# Access Compliance Report

## Public Rights-of-Way

### (Curb Ramps)

Intersection ID: N/A	Main Street: SHARON_VIEW_RD	Cross Street: OHILLIOS_GATE_DR	Location: NW
ADA ID: 33EE01393D7F	Ramp Type: BlendTrans2	Initial Pass/Fail: Fail	Overall Compliance: No
		Severity Score: 1.25

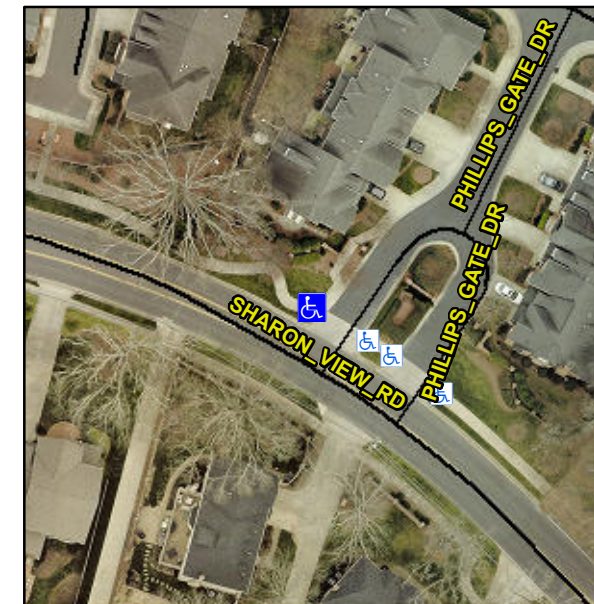
**NO CURB LINE**

**R304.5.3**

Compliance	Description	Data	Compliance	Description	Data
N/A	Ramp Length (in)	58.0	Yes	BlendTrans Slope (%)	2.5
Yes	Ramp Width (in)	74.0	No	BlendTrans XSlope (%)	3.4
N/A	Flare Type LT	N/A	N/A	Flare Type RT	N/A
N/A	Flare Slope LT (%)	N/A	N/A	Flare Slope RT (%)	N/A
N/A	Flare Traversable LT?	N/A	N/A	Flare Traversable RT?	N/A
N/A	Landing Length (in)	N/A	N/A	DWS Provided?	N/A
N/A	Landing Width (in)	N/A	N/A	DWS Contrast?	N/A
N/A	Landing Slope (%)	N/A	N/A	DWS Length (in)	N/A
N/A	Landing X Slope (%)	N/A	N/A	DWS Full Width?	N/A
N/A	Landing Curb? (Y/N)	N/A	N/A	DWS Offset (in)	N/A
N/A	Shared Landing?	N/A			
N/A	Gutter Ponding?	N/A	N/A	Gutter Slope (%)	N/A
N/A	Gutter Lip Ht (in)	N/A	N/A	Gutter X Slope (%)	N/A
N/A	Painted X Walk1?	No	N/A	Painted X Walk2?	N/A
	X Walk 1 Direction	To SE		X Walk 2 Direction	N/A
	X Walk 1 Width (in)	N/A		X Walk 2 Width (in)	N/A
	X Walk 1 Slope (%)	0.6		X Walk 2 Slope (%)	N/A
	X Walk 1 X Slope (%)	2.2		X Walk 2 X Slope (%)	N/A

**Remove & Replace Curb Ramp With Two New Directional Ramps or Equivalent.**
